REMARKS/ARGUMENTS

Appl. No.: 09/855,018
Amdt. dated: March 31, 2005
Reply to Notice of Non-Compliant Amendment of March 17, 2005

Appendix for the Figures

FIG. 4

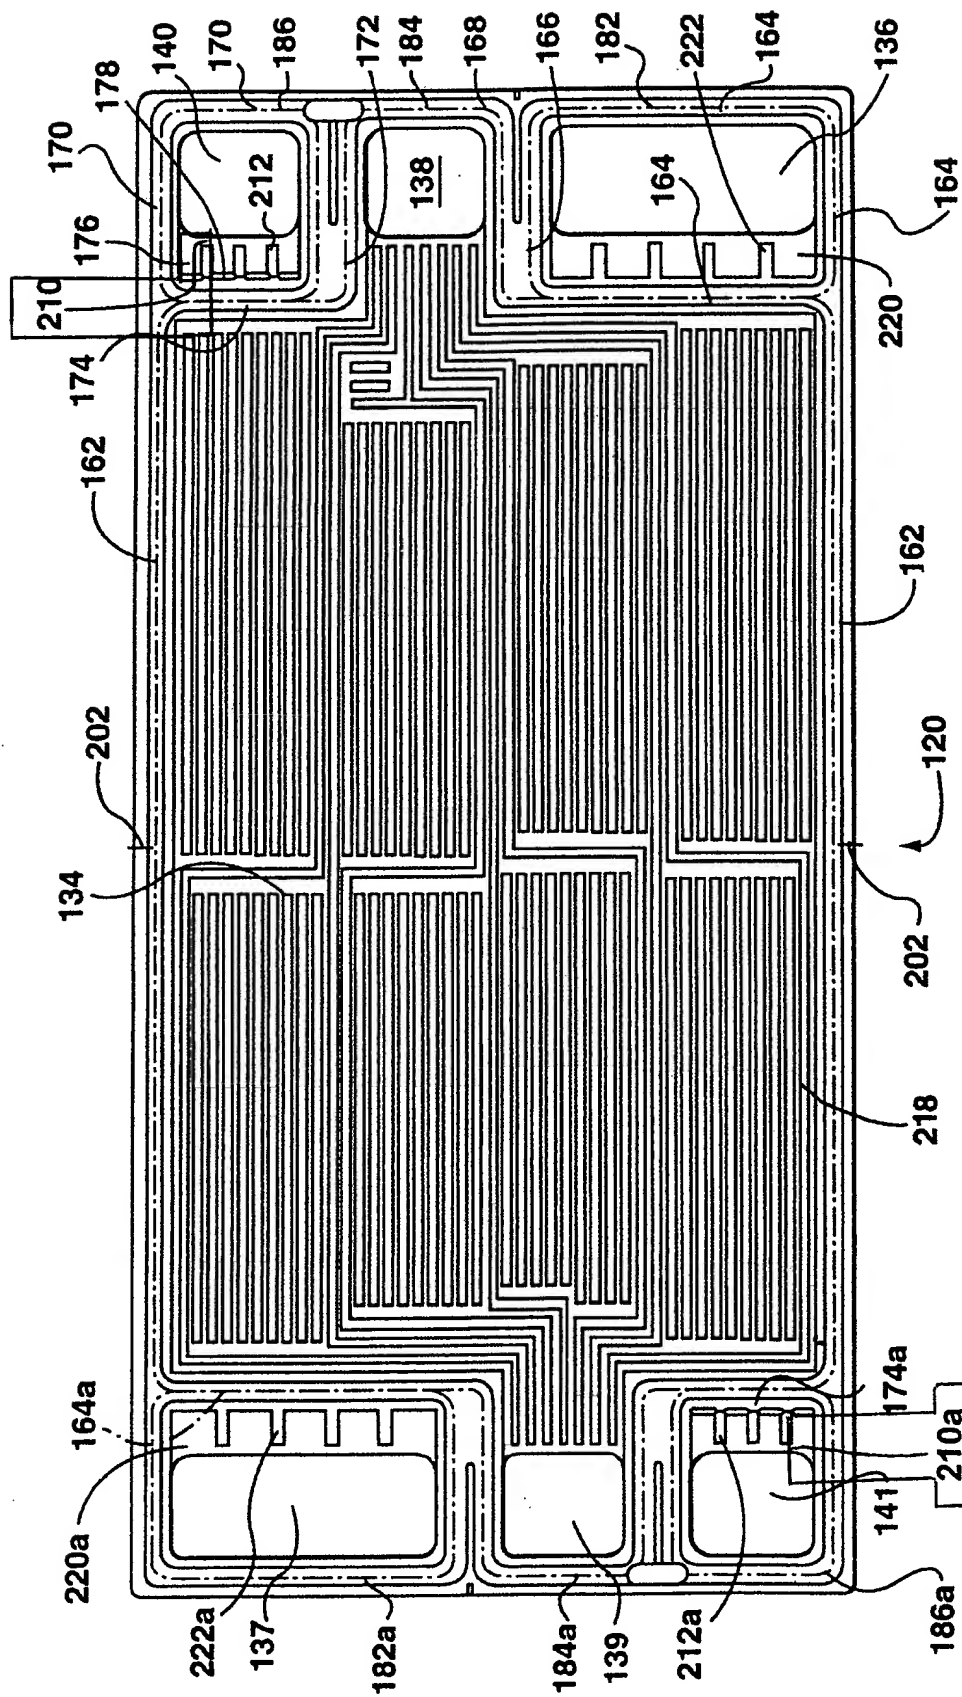
With regards to Figure 4, the leader line for label 210 has been changed to better describe the extension element associated with aperture 140. Also, the label 210a has been added with a leader line to indicate the extension element associated with aperture 141.

In paragraph 4 of the Office Action, the Examiner argued that the drawings must show every feature of the invention specified in the claims. In particular, the Examiner argued that extensions extending on the rear side of the flow field plate for each of the apertures as recited in claim 10 must be shown or the feature(s) canceled from the claim(s).

In response, the Applicant respectfully submits that the drawings do show extensions extending on the rear side of the flow field plate for each of the apertures that provide or remove the reactant gas that flows in the reactant flow channels on the front sides of the flow field plates as recited in amended claim 10. These extensions may not have been clearly labeled in the Figures as filed. However, the Applicant submits that amended Figures 4 and 8 now clearly show this feature. In particular, originally filed Figure 4 had

an incorrect leader line from label 210. This has now been corrected to clearly show the location of the aperture extension in Figure 4. Support for this amendment is in Figure 5 as filed and line 24 on page 17 of the application as filed. Reference label 210a has been added to show the extension associated with aperture 141 on the bottom left corner of Figure 4. With regards to Figure 8, shown therein are aperture extensions 230 and 230a for apertures 136 and 137 respectively. The Applicant has corrected the leader lines to more clearly show the location of the extension. Support for these features is in the text on lines 24-32 on page 18 of the application as filed. Further, the Applicant submits that apertures 140 and 141 for the flow field plate shown in Figures 4 and 5, and apertures 136 and 137 for the flow field plate shown in Figures 8 and 9, are the only apertures that are used for providing or removing reactant gas in those flow field plates (i.e. one flow field plate provides for the flow of a fuel and the other flow field plate provides for the flow of an oxidant). Accordingly, the Applicant respectively submits that the features recited in claim 10 are supported by the Figures.
